# Brookfield

Still River Greenway Connection

May 10, 2016

Figure 10. Medium Term Recommendations

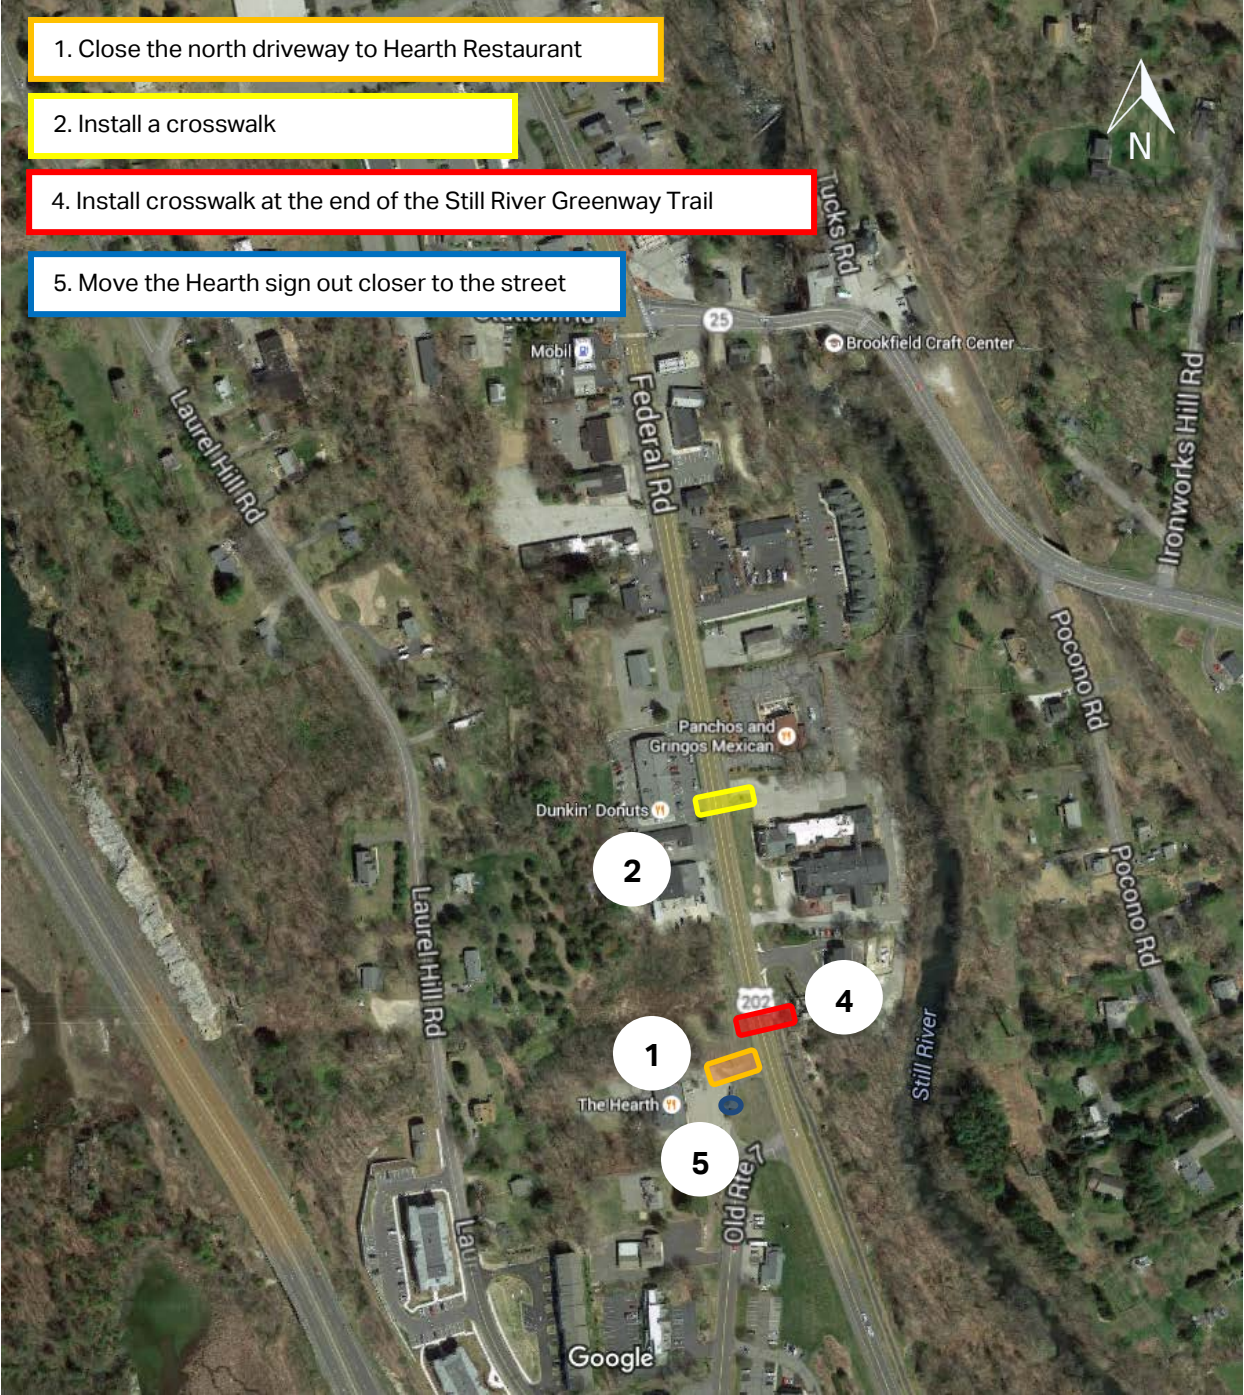
1. Close the north driveway to Hearth Restaurant unless both driveways are required by fire department, or precluded by some type of agreement with CT DOT.
2. Install a crosswalk in the area of the Brookfield Deli, Subway and Dunkin Donuts.
3. Add a bus stop at the intersection south of Poncho's Gringo's.
4. Install crosswalk at the end of the Still River Greenway Trail. This will require adequate signage along with ADA compliant sidewalk ramps. (Figure 9)
5. Move the Hearth sign out closer to the street.
